TOWN OF ADDISON CHANGE ORDER FORM

**Change Order Number:** 2

**Project Name:** Addison Airport US Customs and Border Protection Facility

**Project Number(s):** 19-97

**Penal-Ware® 1415: 15" Lav-Toilet Comby with Lavatory Multi-Sided Bowl**

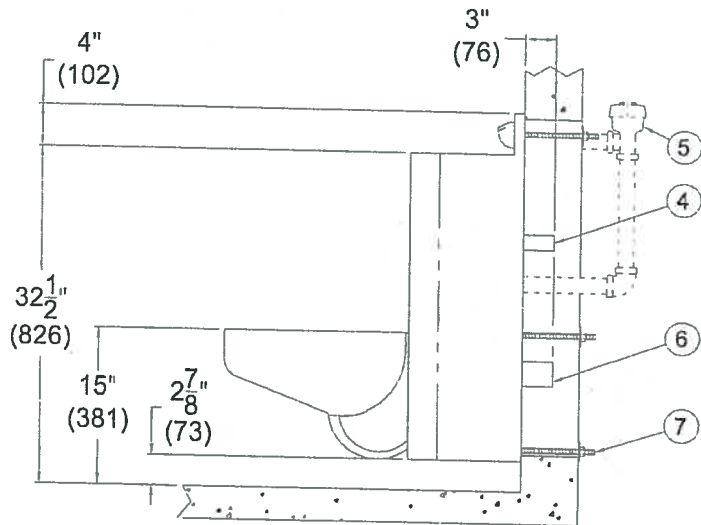
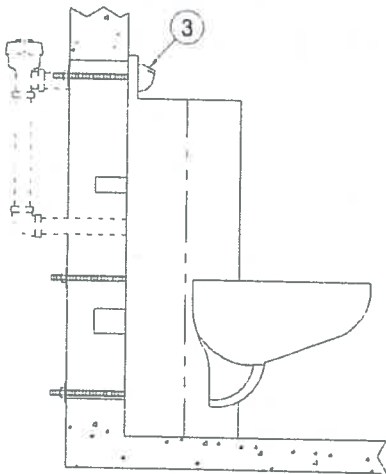
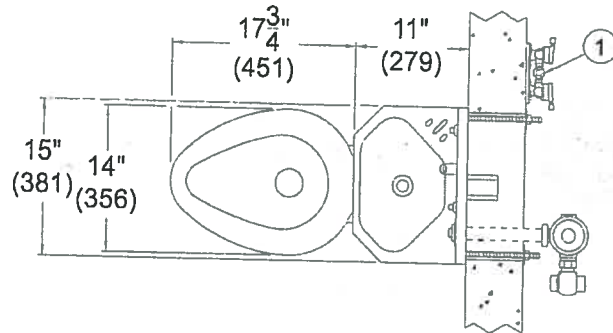
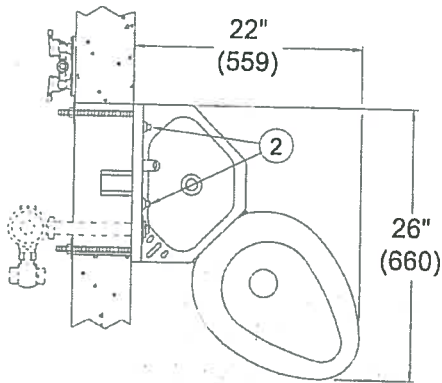
- As requested by Customs and Border Protection, hold room toilets and lavatory were revised from separate toilets and lavatory to combination toilet/lavatory fixtures.

Plumbing bid per RFI 89 and specs. Including the following fixtures;

- Install and provide new WC/Lavatory combo unit
- Change fixture type from fixture schedule to RFI 89
- 6-8 week lead time from the factory (non-stock item)
- Pricing based on normal work hours M-F, no expedited schedule
- MEP ceiling coordination meeting will be required prior to overhead piping
- Fixtures to be per schedule or equal.

Provide and install Acorn Penal-Ware® 15" wide Lav-Toilet Comby (specify model number and options). Fixture shall be fabricated of type 304 stainless steel. Construction shall be seamless welded and exposed surfaces shall have a satin finish. Countertop shall have raised soap ribs. Provide Air-control pneumatically operated pushbutton valve. Valve and bubbler conform with lead free requirements for NSF61, Section 9 and CHSC 116875. Toilet shall be concealed blowout jet type with an elongated bowl, a self-draining flushing rim, and an integral contoured seat. Toilet shall meet ASME A112.19.3 and CSA B45.4 requirements and will flush with a minimum of 25 PSI flow pressure when used in conjunction with a minimum of 1.28 gpf. Toilet trap shall have a minimum 3-1/2" seal that shall pass a 2-1/8" diameter ball and be fully enclosed. Cabinet interior is sound-deadened with fire-resistant material. Fixture shall withstand loadings of 5,000 pounds without permanent damage. Fixture shall be furnished with necessary fasteners for proper installation.
